From: Pearsons TV & Appliances
Sent: 06 November 2019 13:15
To: Ailsa Teasdale;
Subject: Change of power. Revised Drawings and BS4142

Project
**GRIBDALE STABLES, DIKES LANE
GREAT AYTON TS9 6HJ**

Change of use from Equine Trekking
Cente to Cycle Hire Shop, Cafe and
Holiday Accomodation.

Title PROPOSED ELEVATIONS	
Date September 2018	Scale A3 - 1/100
Drawn A V	Drawing No. S17.24(21)2D

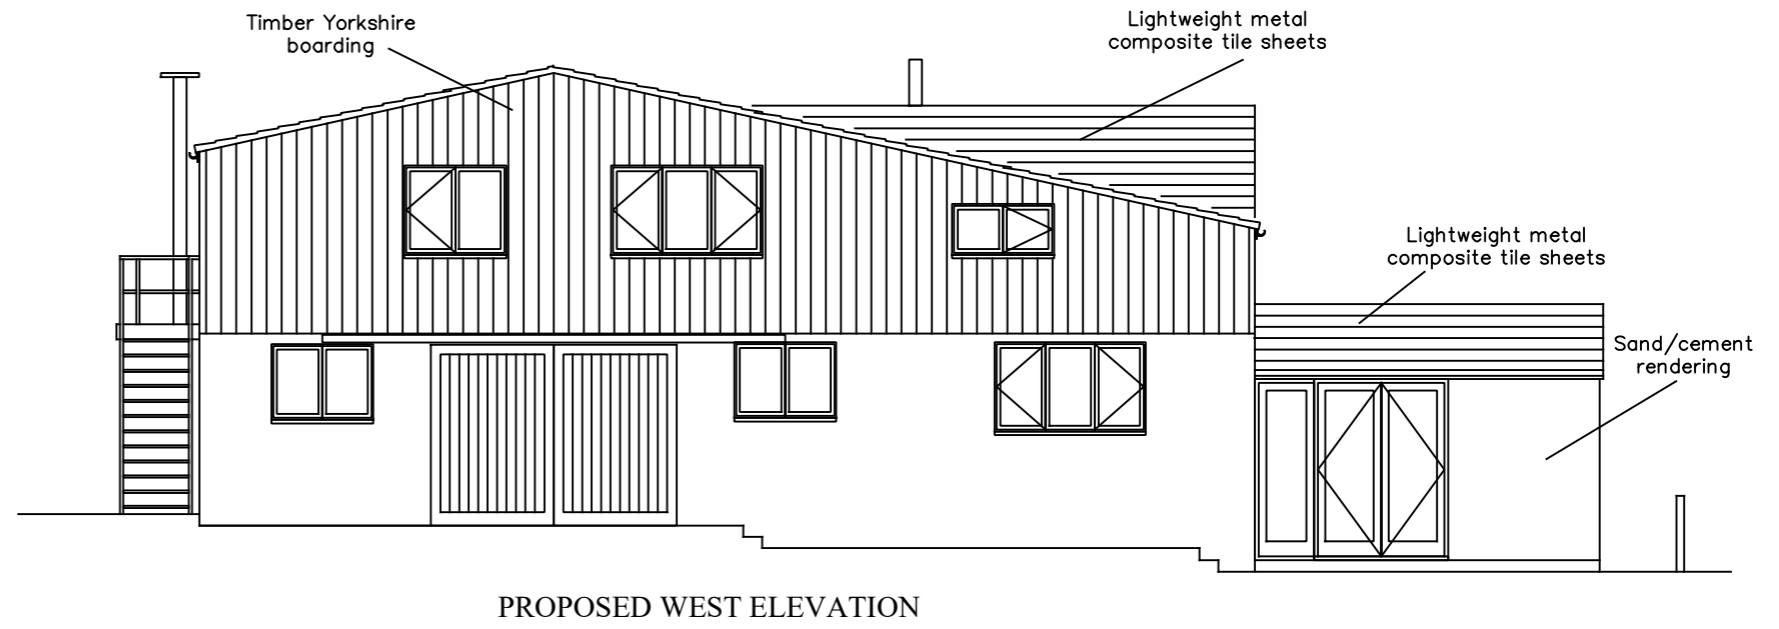
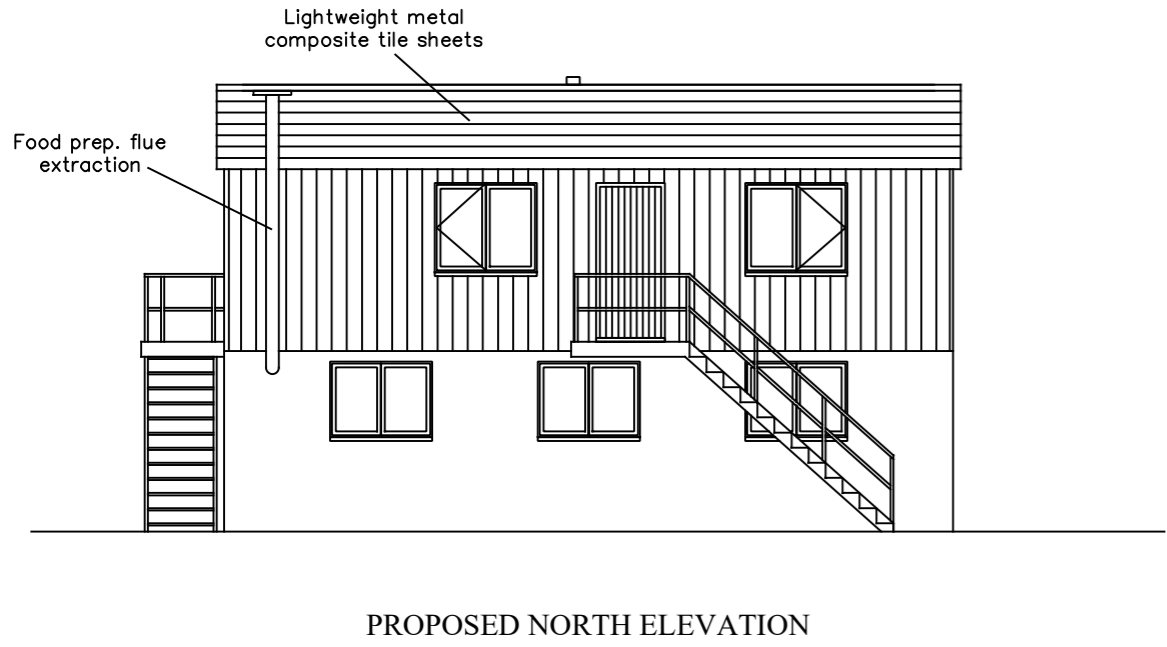
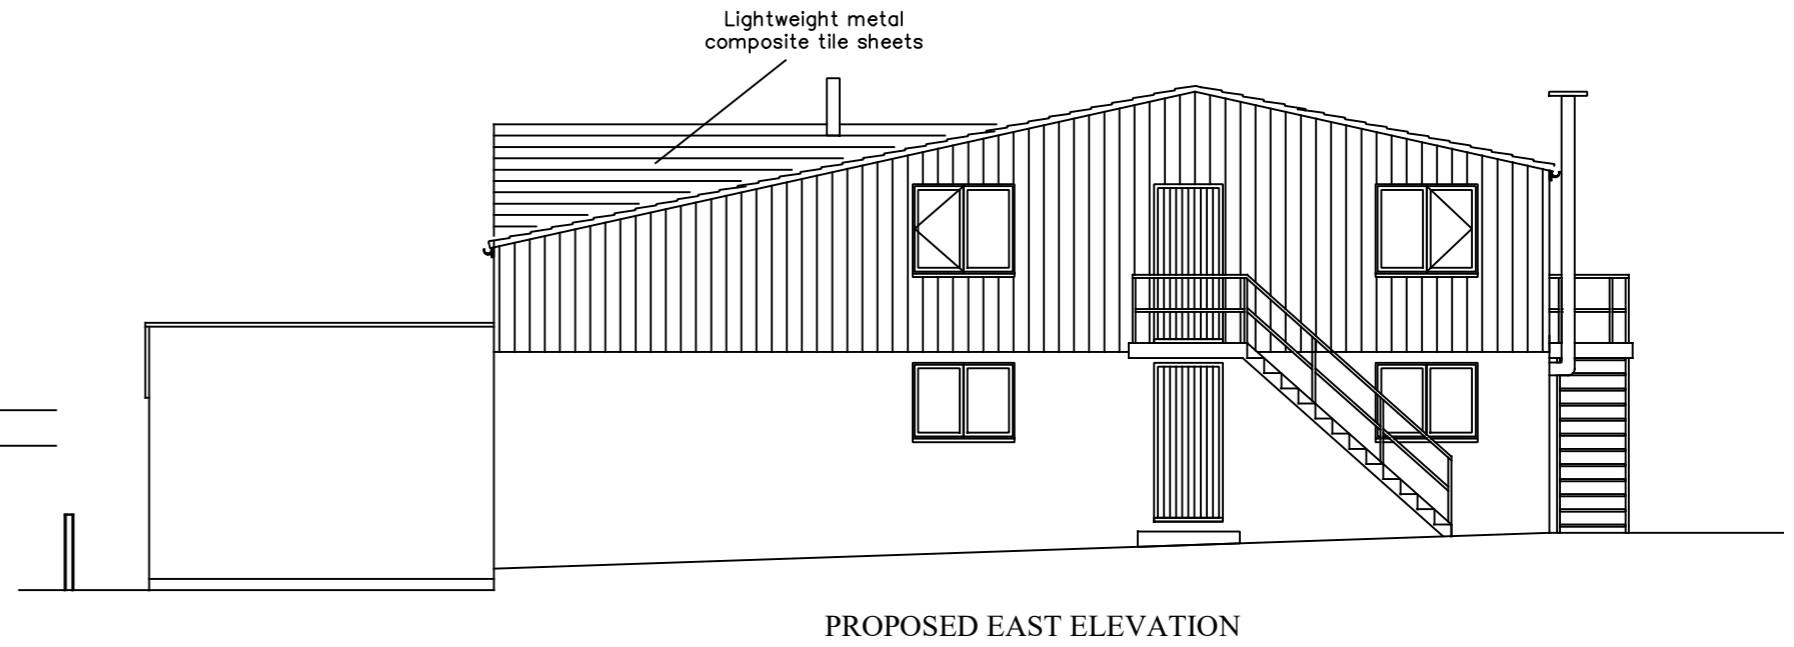
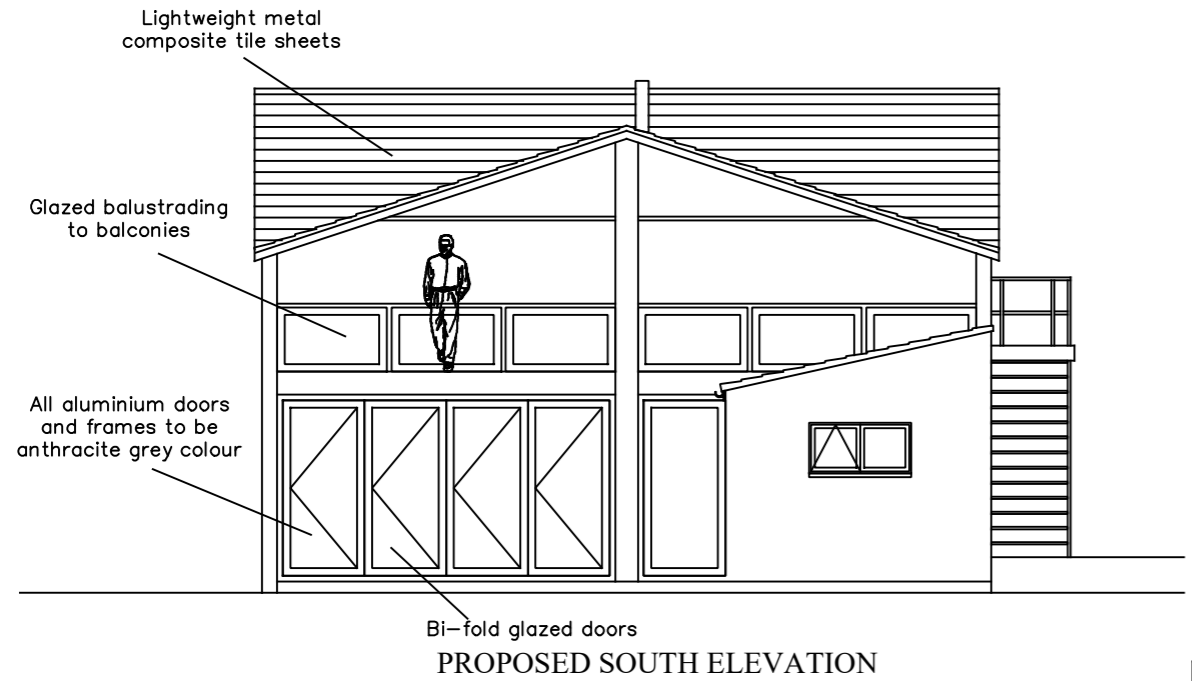
I have attached the BS4142 from GT Acoustics. In his Conclusion he has suggested raising the height of extractor by 0.5m. You will note from the attached plans I have done this already even though he only recommended it. His recommendation for an inlet silencer to reduce noise within the kitchen will be addressed at the time of installation but won't be a problem if required.

Rev	Date	Note
D.	6nov19	Food prep. extraction chimney raised by 500mm
C.	24oct19	Reference to solar shingles omitted.
B.	10july19	General revisions
A.	6mar19	Entrance foyer relocated. Roof tiles and cladding revised.

Title PROPOSED PLANT ROOM	
Date September 2018	Scale A3 - 1/100
Drawn A V	Drawing No. S17.24(21)3C

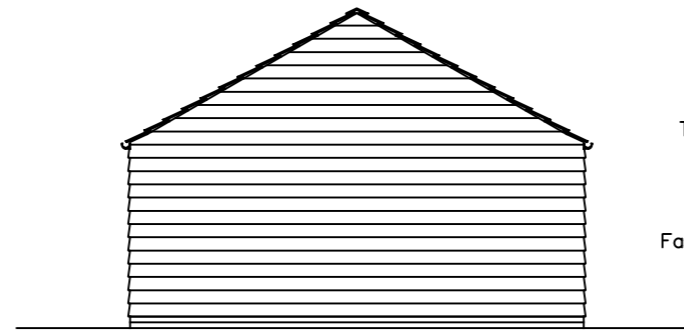
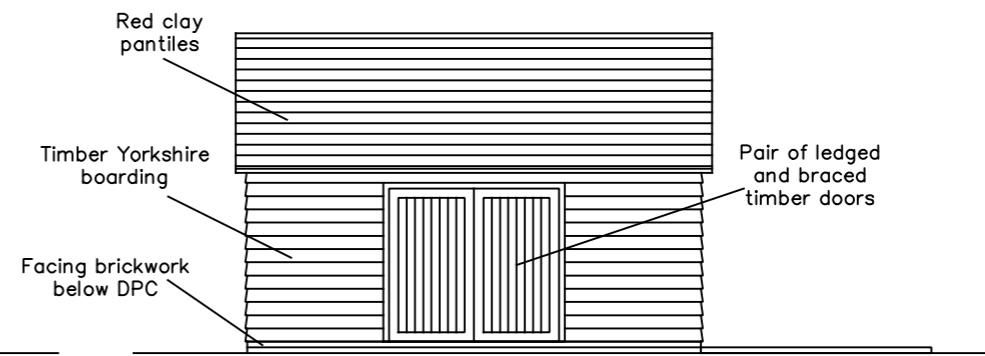
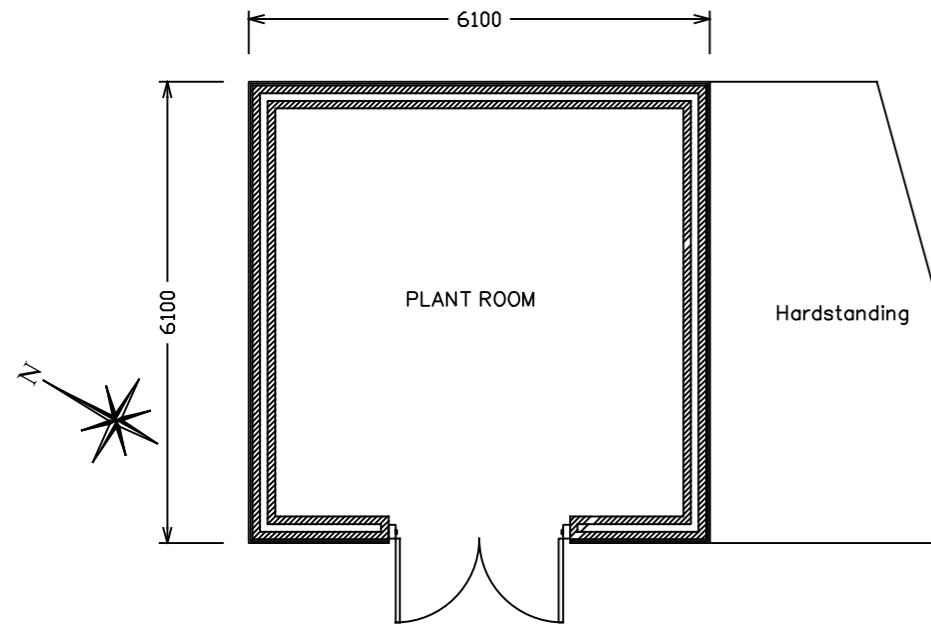
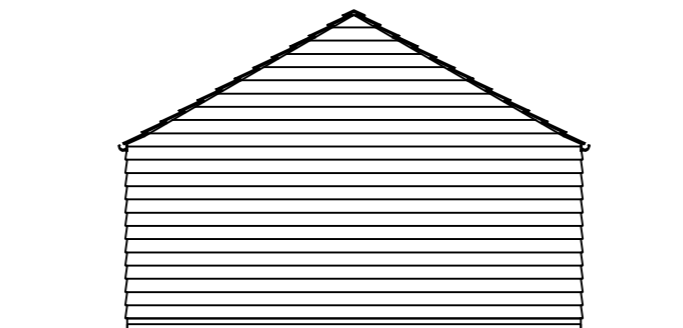
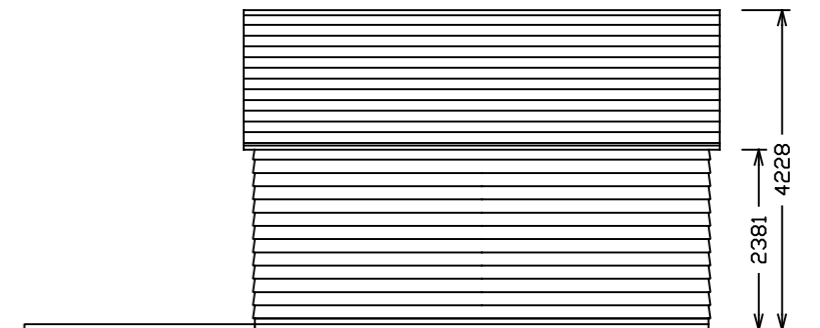
Please find attached an amended set of plans without the solar array, easy grid battery system, back up generator and Biomass Boiler.

Rev	Date	Note
C.	6nov19	Biomass boiler omitted
B.	24oct19	Reference to LPG generator omitted.
A.	6mar19	Roof and cladding revised.
